### MEMORANDUM

**FILE REF.:** CDRC CASE # Z/S 12-5450 Cielo Colorado Subdivision

Cielo Colorado, LLC. Applicant, Jim Siebert, Agent, requests Master Plan Zoning approval for a 24-lot residential subdivision on 246.30 acres  $\pm$  within Tract 15A-2 of the Eldorado at Santa Fe Subdivision. The property is located on the east side of US 285, off Camino Acote, within Sections 21 & 22, Township 15 North, Range 10 East (Commission District 4).

**APPROVAL SOUGHT:** Master Plan Zoning Approval for a 24 lot residential subdivision on 246.30 Acres  $\pm$ .

1995 (amended 2000) Master Plan

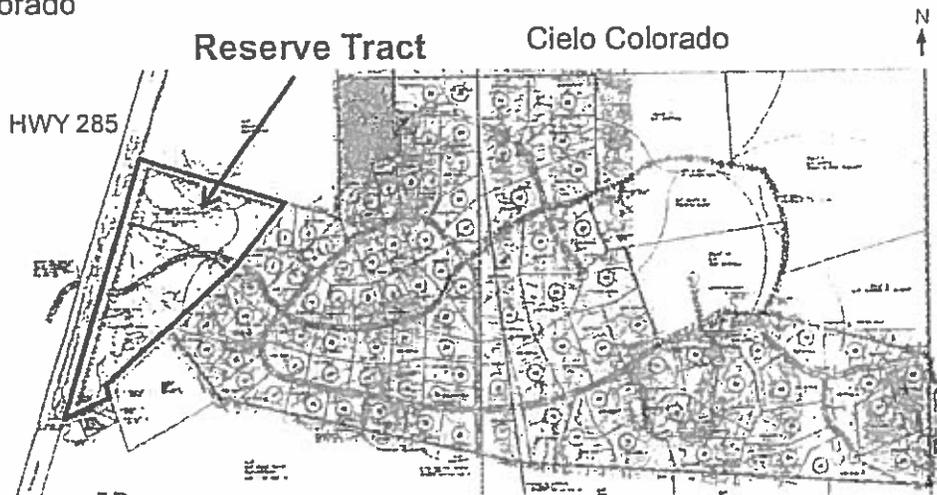
Re: CDRC CASE # Z/S 12-S450 Cielo Colorado Subdivision  
Master Plan Zoning for a 67-lot residential subdivision on 257.16 Acres +/- within  
Tract 15A-2 of the Eldorado at Santa Fe subdivision

Proposed 2013 Master Plan (detail)

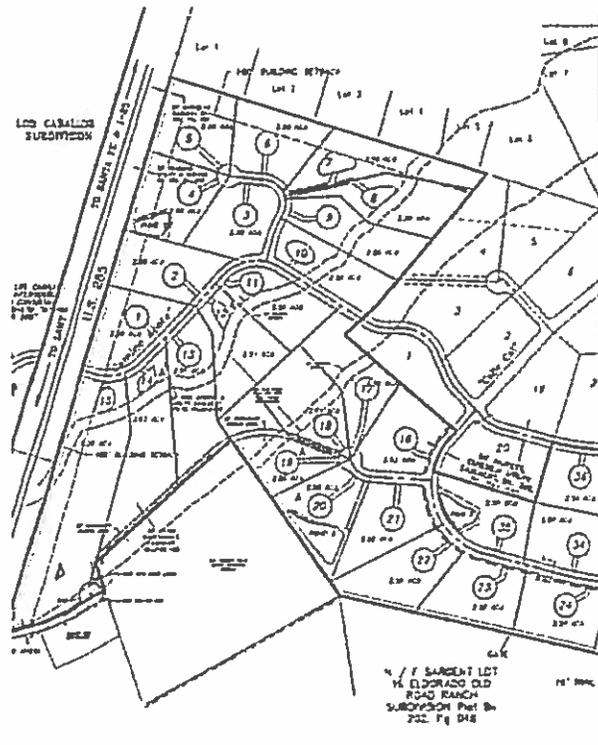
The new 2013 Master Plan populates the Reserve Tract with 15 lots:
